June 10, 2016

Subject: Acorn Development LLC Redevelopment Projects and VCP Submittal_06.10.16
Block 19 Response Letter
2101 7th Avenue, Seattle, Washington
VCP Project No.: NW3011
File No. 20434-001-00

APPENDIX A
February 18, 2016 Letter from Ecology

Figure 1

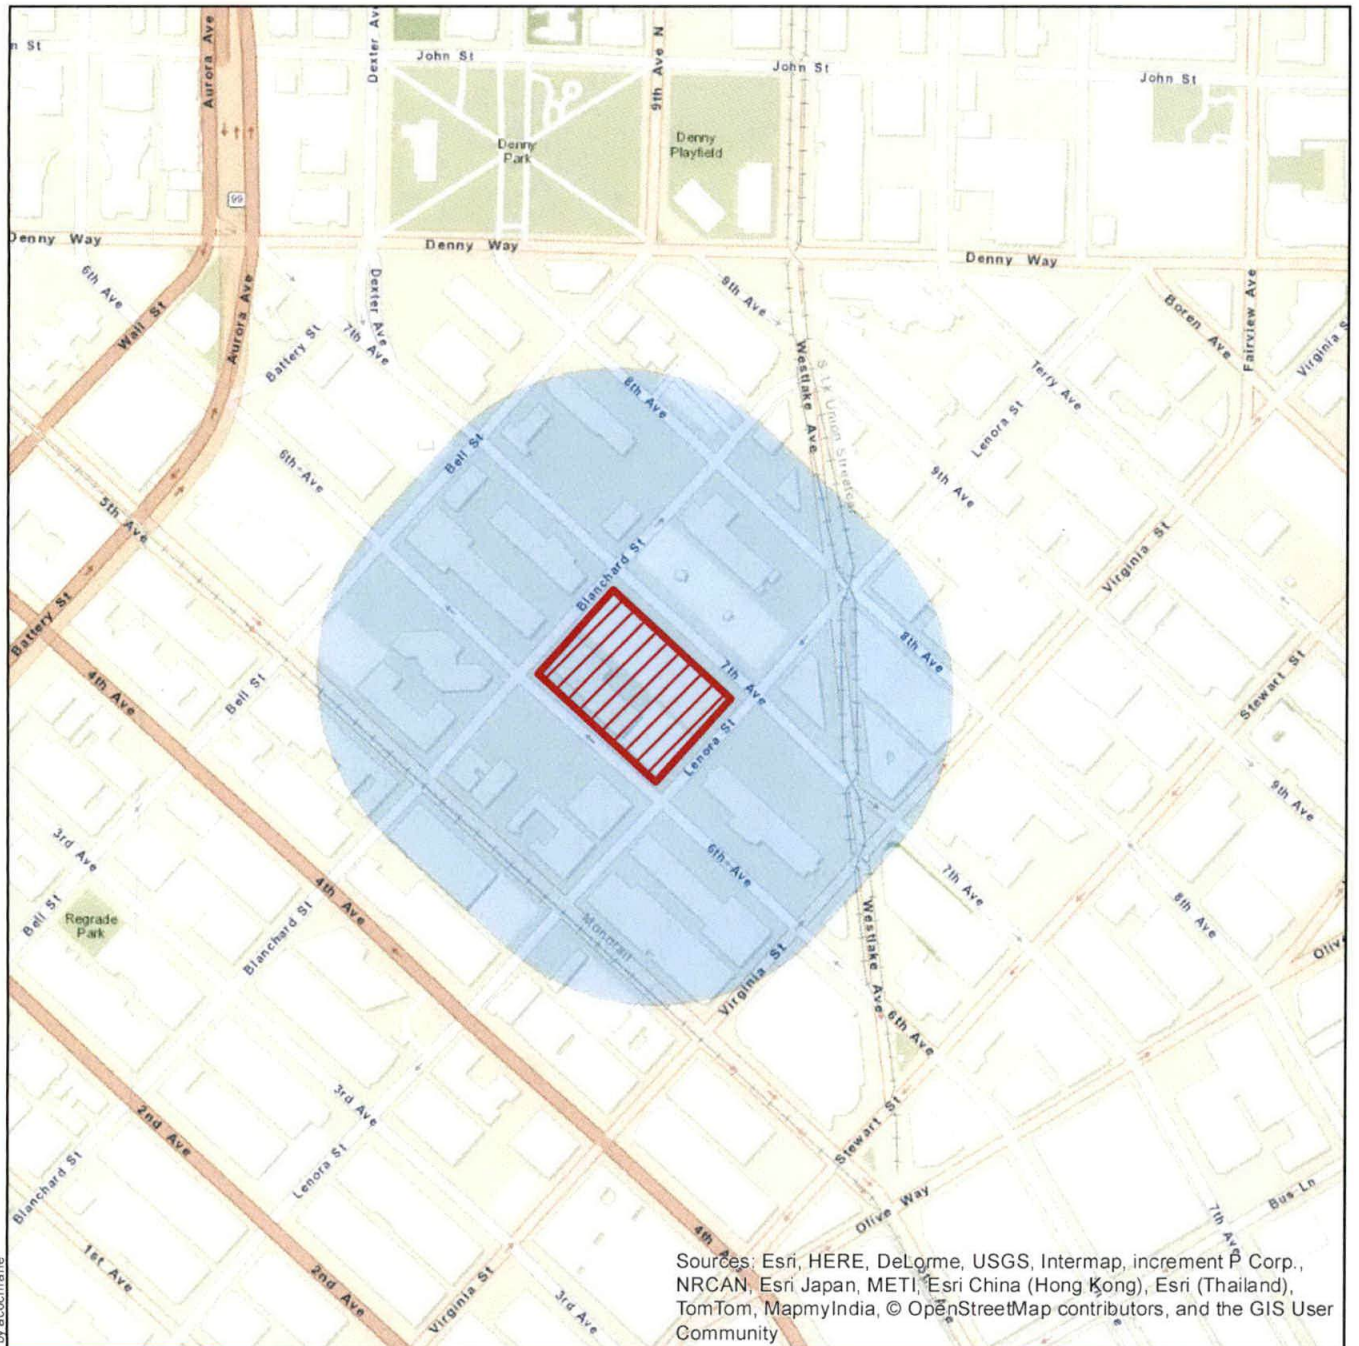
- The Site does not qualify for the Terrestrial Ecological Evaluation (TEE) exclusion selected per WAC 173-340-7491 as Denny Park is located approximately 300 feet north of the Site and it is considered to be more than 1.5 contiguous acres of undeveloped land. Please include the completed TEE form in future submissions.

As shown in the Terrestrial Ecological Evaluation (TEE) Site Plan, Figure 1, Block 19 is located approximately 800 feet to the south of Denny Park. Based on this, the subject property qualifies for an exclusion from the TEE based on the Washington Administrative Code (WAC) 173-340-7491(1)(c)(i), which states, “there is less than 1.5 acres of contiguous undeveloped land on the site or within 500 feet of any area of the site.” The completed Terrestrial Ecological Evaluation Form is included in Appendix B.

Figure 2

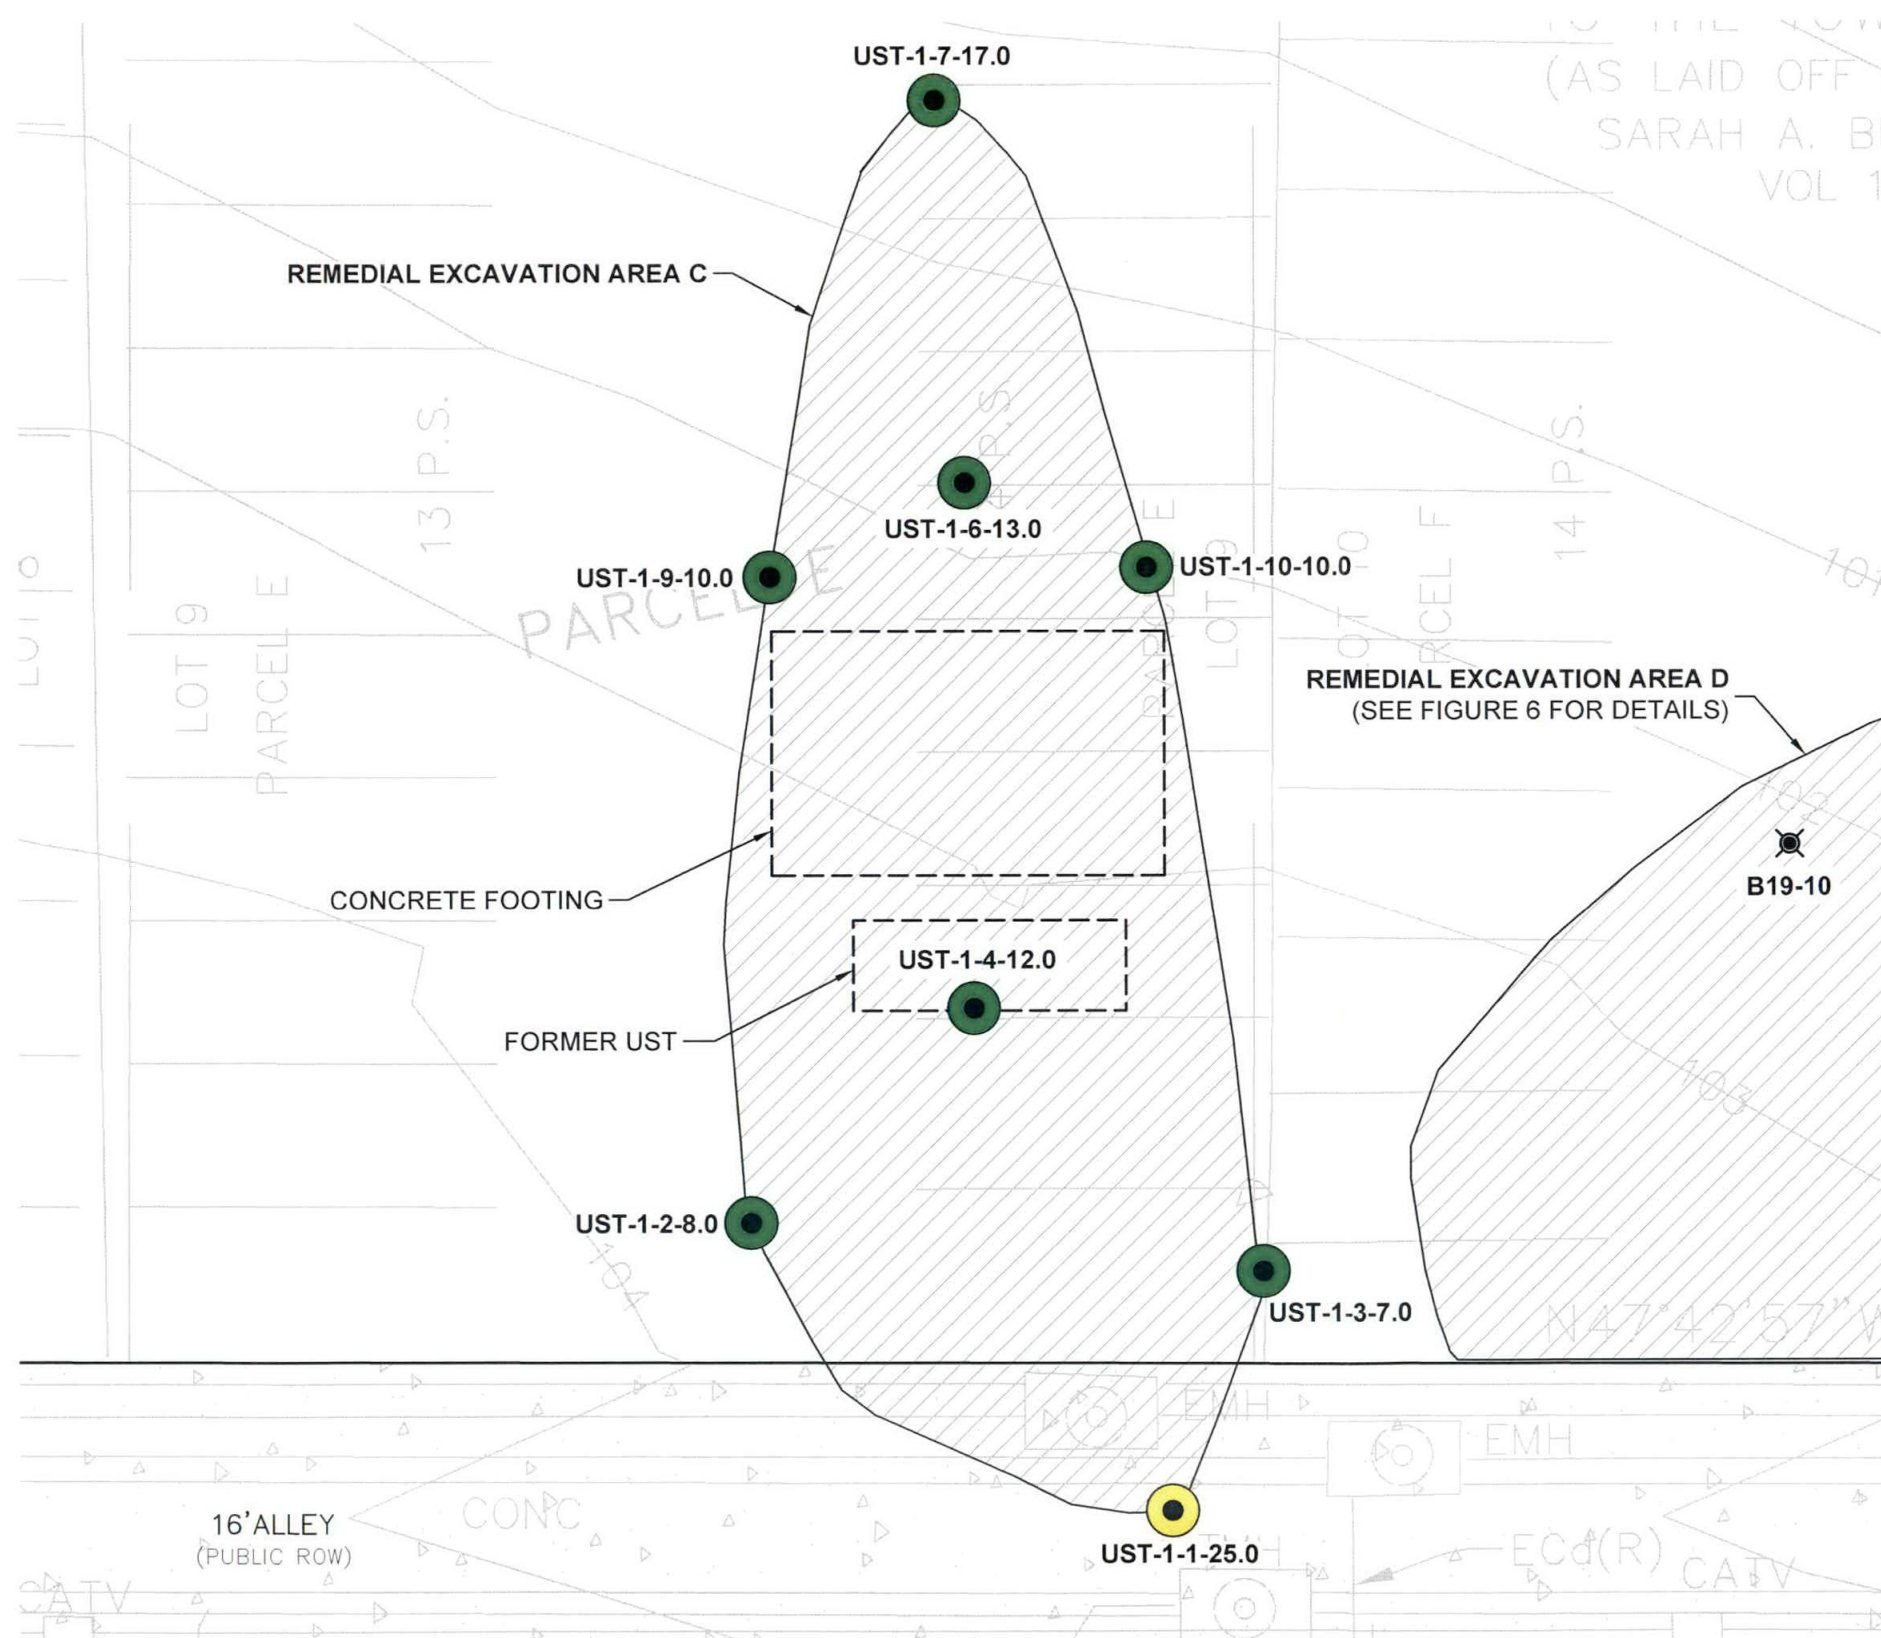
- Your characterization of the Site is not sufficient to establish cleanup standards and select a cleanup action. Soil samples were collected after discovery of contaminated areas during construction activities at the Property and were collected and analyzed for TPH-D and TPH-O. Several of the samples contained concentrations above the MTCA Method A cleanup levels for TPH-D and/or TPH-O, however, only limited areas were sampled for PAHs. None of the samples were analyzed for volatile organic compounds (VOCs) or metals even though some of the exceedances were in an area known to have a history of vehicle maintenance activities.
- Confirmation samples obtained during post-excavation activities, were not collected below the areas where contamination was previously identified (PCS-4, SP-2, and PCS-2). Therefore, complete removal of impacted soil cannot be confirmed at this time.

- Samples PCS-4 and SP-2 were obtained from remedial excavation area C and PCS-2 was obtained from remedial excavation area E. Confirmation soil samples UST-1-6-13.0, UST-1-4-12.0 (in remedial excavation area C) and EX-10-5.0 (remedial excavation area E) were obtained beneath each of the characterization samples (within approximately 2 to 5 feet). These confirmation samples are representative of soil conditions at the extent of the remedial excavation directly below samples PCS-4, SP-2 and PCS-2, respectively. The approximate locations of confirmation soil samples obtained from Areas C and E are shown in figures 2 and 3, respectively.
